Service Bulletin 589 Issue 1 - 05.2021

Subject: Fuel Hose Clip Alignment				
Bulletin Number	Models Affected	VIN Range		Markets Affected
589	Bonneville T100 Bonneville T120 Bonneville T120 Black Bonneville Bobber Bonneville Speedmaster Scrambler 1200 XE Scrambler 1200 XC Scrambler 1200 Steve McQueen Edition Speed Twin Street Scrambler Street Scrambler Sandstorm Street Twin Street Twin Goldline Thruxton RS	From AE5477	To AH3827	All markets
589	Bonneville Bobber Black Street Scrambler	From AE5477	To AH3827	China only

Fuel Hose Clip Alignment

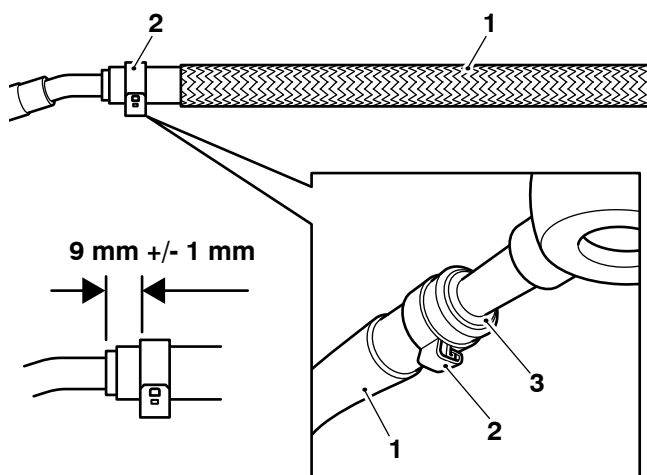
Internal investigations have identified the possibility of the fuel hose clip to cause damage to the fuel pump plate on the above models. Dealers are requested to realign the clip on the fuel hose as described in the procedure below.

7. Align the clip to its correct position. The clamp section of the clip should be rotated 180° so it faces away from the fuel pump plate when the hose is fitted. For all markets except China, the clip edge should be 9 mm +/- 1 mm from the fuel hose flange. For models sold in China, the clip edge should be 6.5 mm +/- 1 mm from the end of the fuel hose rubber protective sleeve.
